**CALPINE
BLUE HERON
ENERGY CENTER**

Sufficiency Responses

Re: Calpine Construction Finance Company, L.P.
Blue Heron Energy Center
Site Certification Application No. PA00-42
DOAH Case No. 00-4564EPP
Responses to Agency Sufficiency Comments

FIGURE SJRWMD-4.
LOCATIONS FOR WATER LEVEL DRAWDOWN ANALYSIS

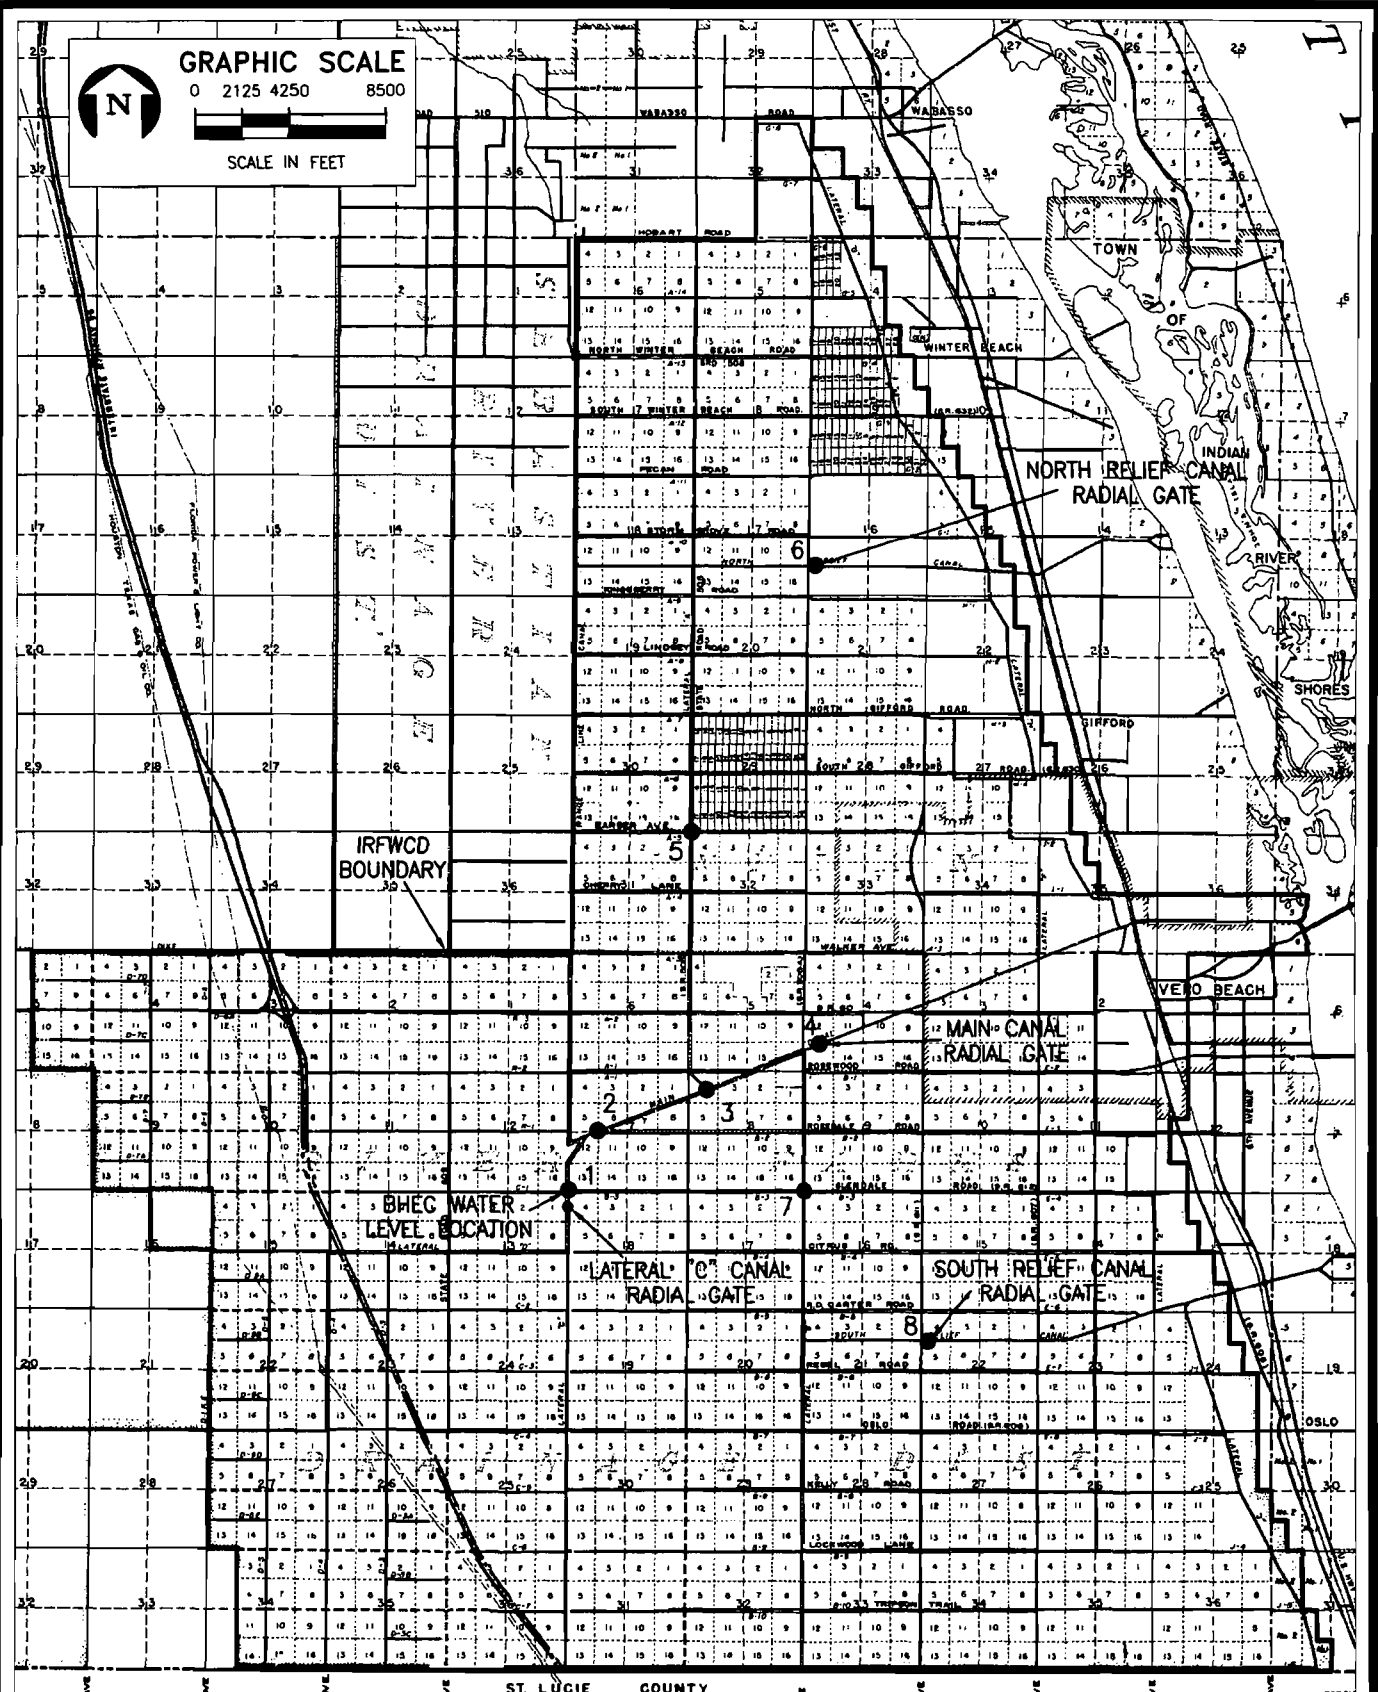
It is our understanding that Calpine—Blue Heron Energy Center is currently working with the Indian River Farms Water Control District, Indian River County, and the SJRWMD to prepare a comprehensive surface water model for the Indian River Farms Water Control District. Please provide surface water modeling which shows the expected drawdown associated with the proposed surface water use. The modeling should evaluate the drawdown due to proposed withdrawals and confirm that existing legal uses are not adversely impacted. If a determination is made that there is a potential for the consumptive use to adversely effect water level stages, vegetation, or crops on lands not owned or controlled by the applicant, then describe how these impacts would be avoided and/or mitigated. [Paragraphs 10.2 (e), (f), (g) & (p) and 10.3 (b) & (d), A. H.]

To quantify the water level drawdown impacts, simulated pre- and post-development canal water levels were compared at eight locations, as shown in attached Figure SJRWMD-4. Attached Figure SJRWMD-5 shows the pre- and post-development water levels at the intake (location No. 1). Similarly, attached Figures SJRWMD-6 through -12 show the pre- and post-development water level comparisons at location Nos. 2 through 8, respectively. Attached Figure SJRWMD-13 shows the net water level drawdown at the water intake (location No. 1) due to the plant water use. Similarly, attached Figures

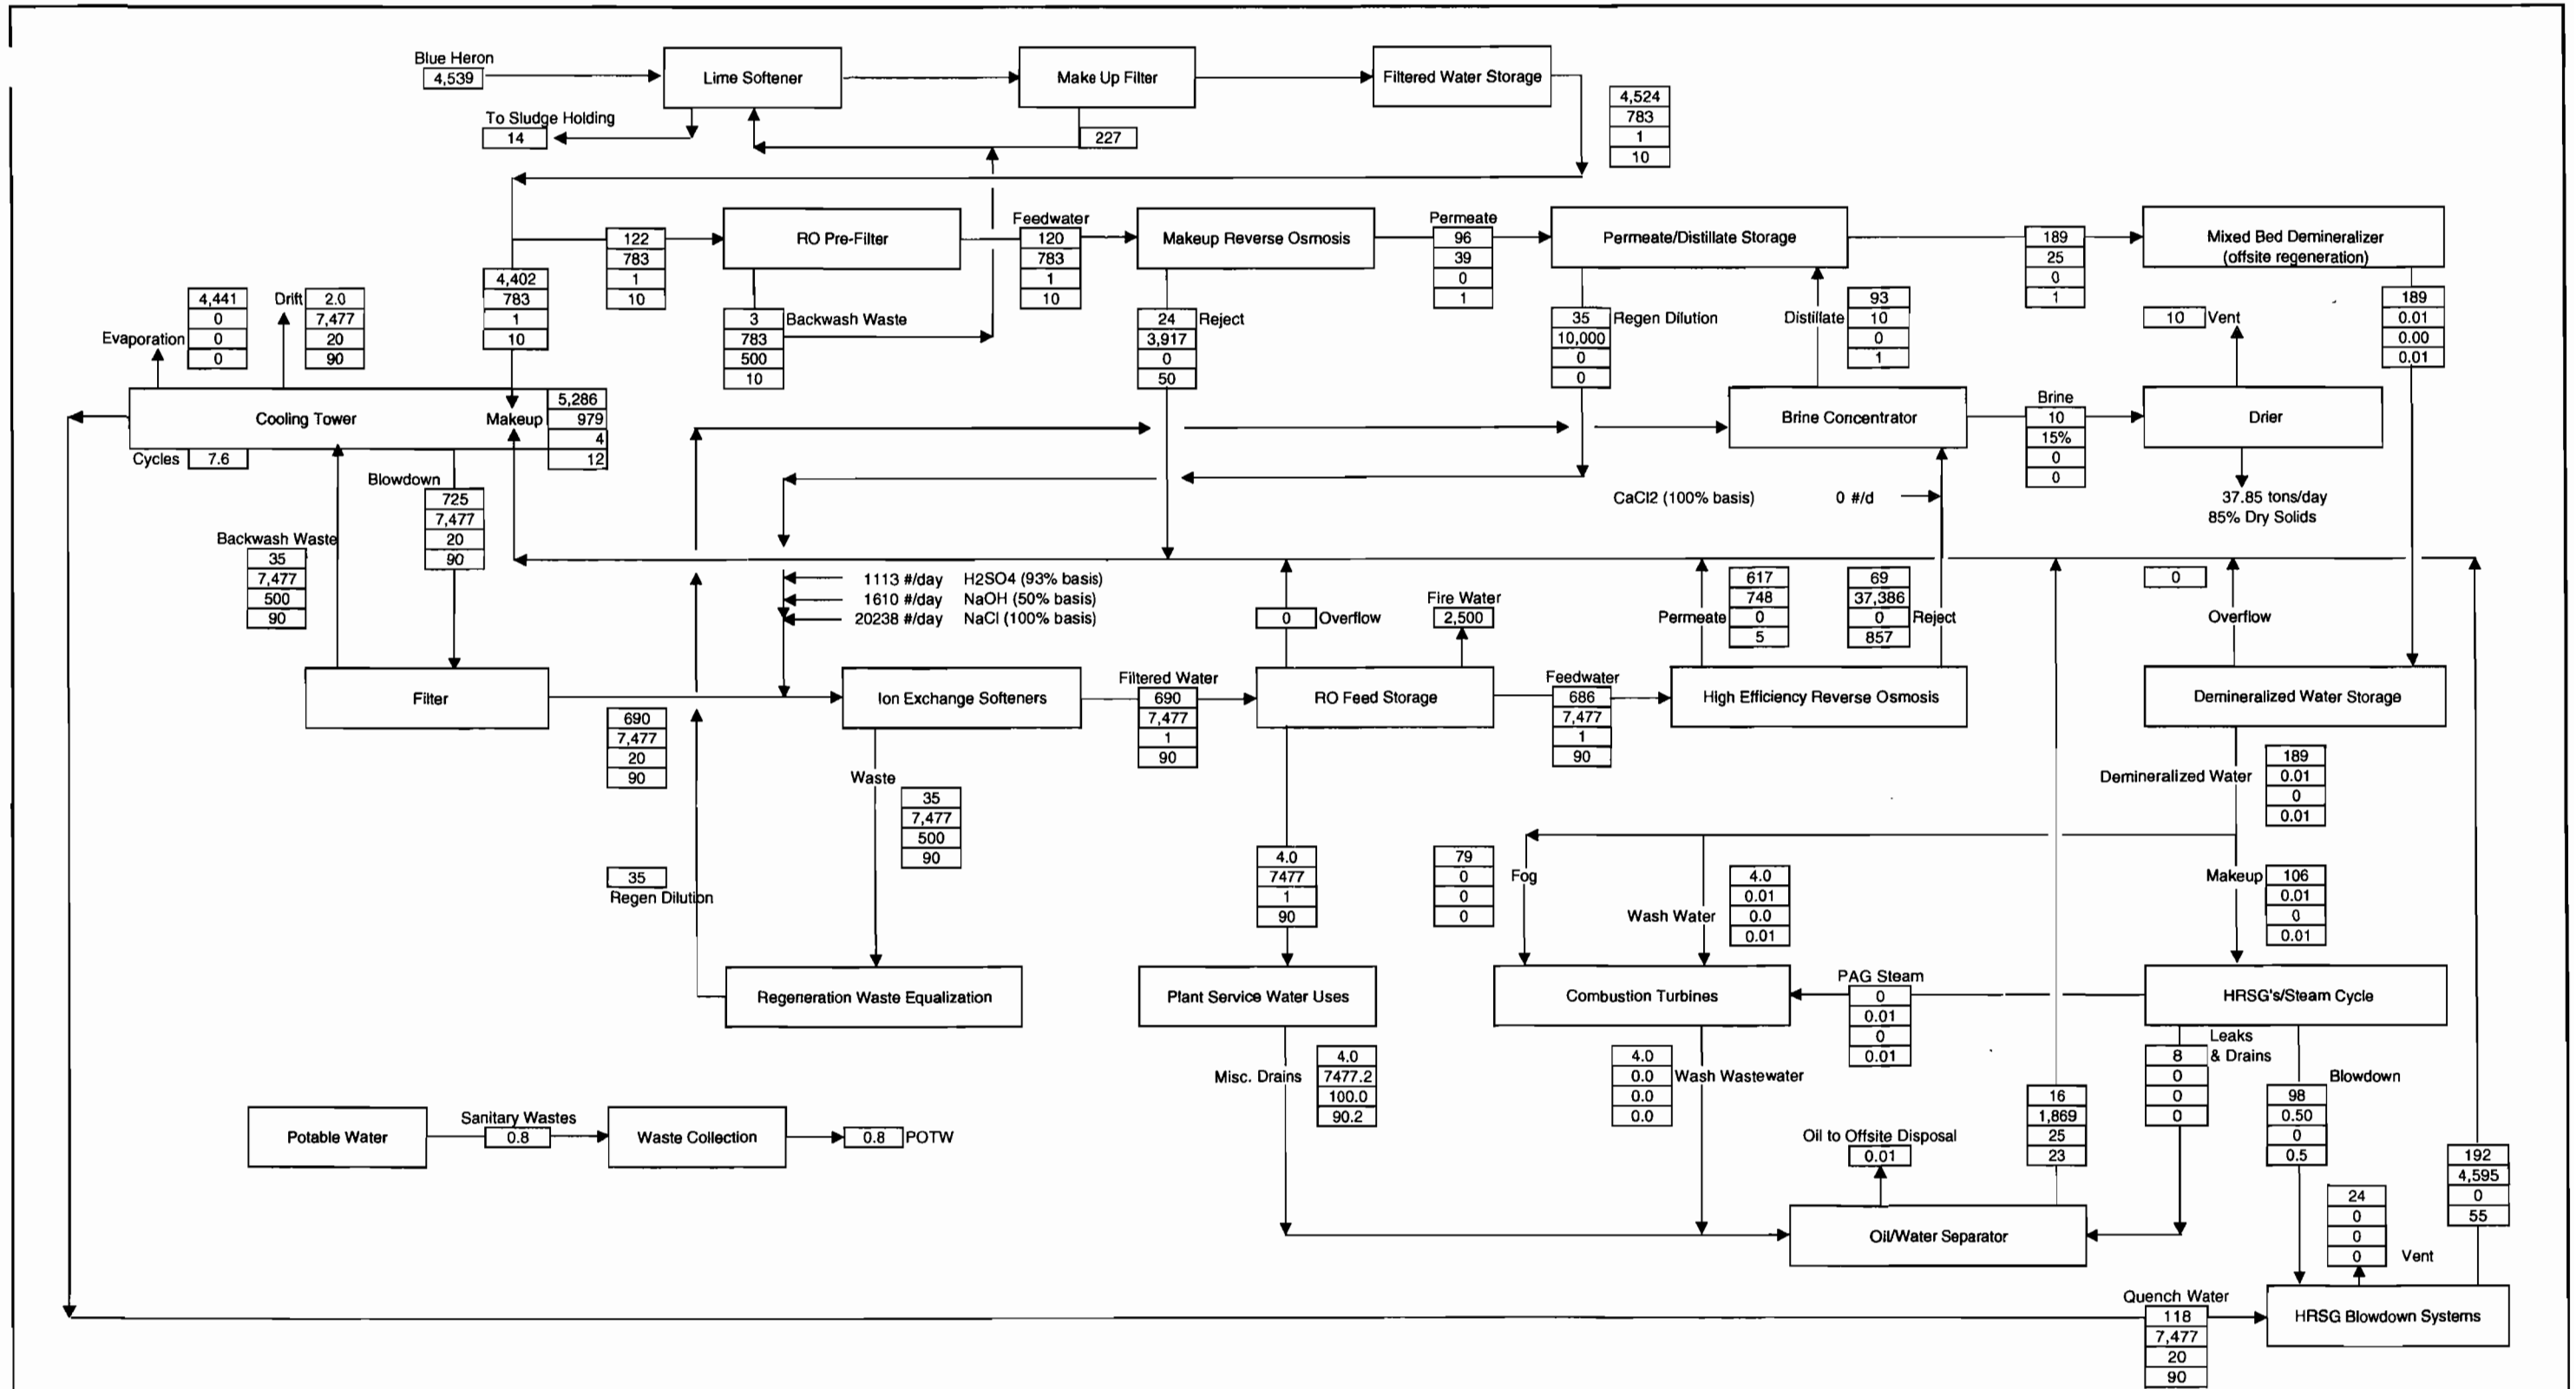
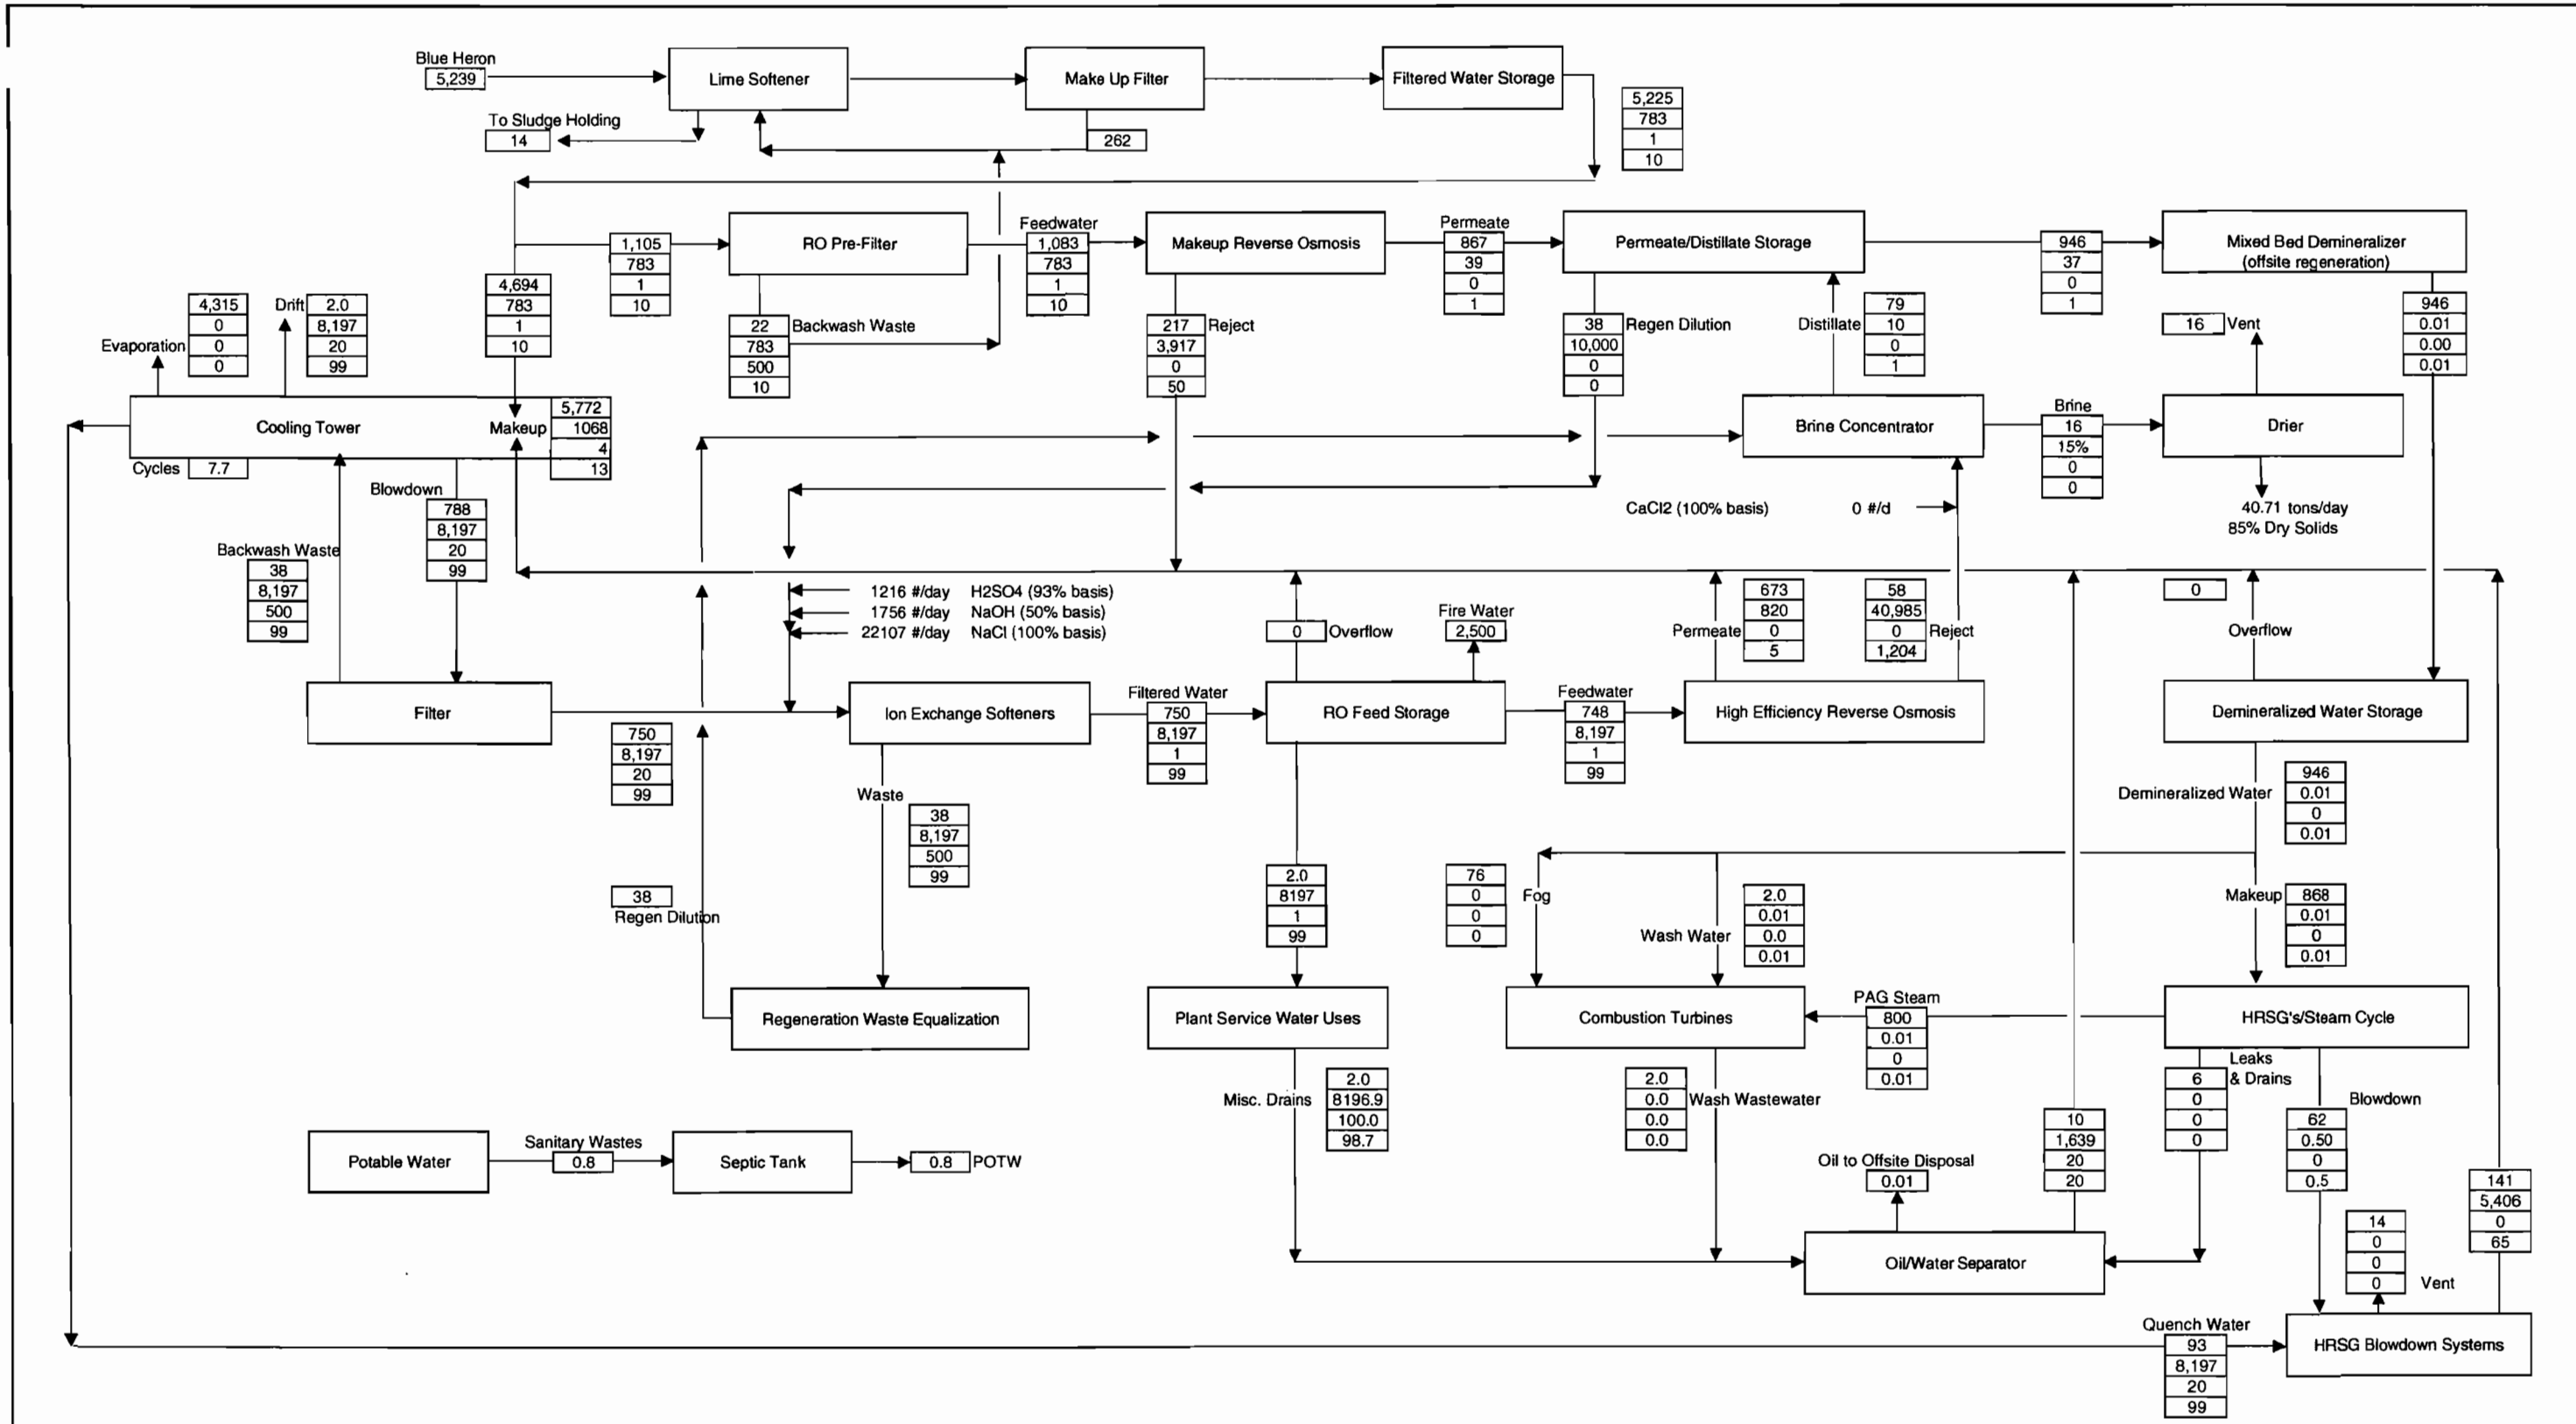
Please provide a basis for the peak day water uses shown on Figure 2-3. Were the water use amounts based on engineering calculations, data from similar type plants, or a combination of both? Please provide a copy of the calculations and/or data relied upon. [Paragraphs 10.2 (a), (b) & (h) and 10.3 (a) & (b), A.H.]

Water balances showing peak daily and average annual water use, reflecting the updated engineering on this system, are included in Attachment B to these responses along with supporting calculations. These water use values are based on standard plant design data used for similar plants around the country. Calpine has over 40 operating facilities based on this general design, natural gas-fired combined cycle, and an additional 27 facilities in construction. Data from similar plant designs have been combined with vendor-supplied information to produce the basis for these site-specific calculations.
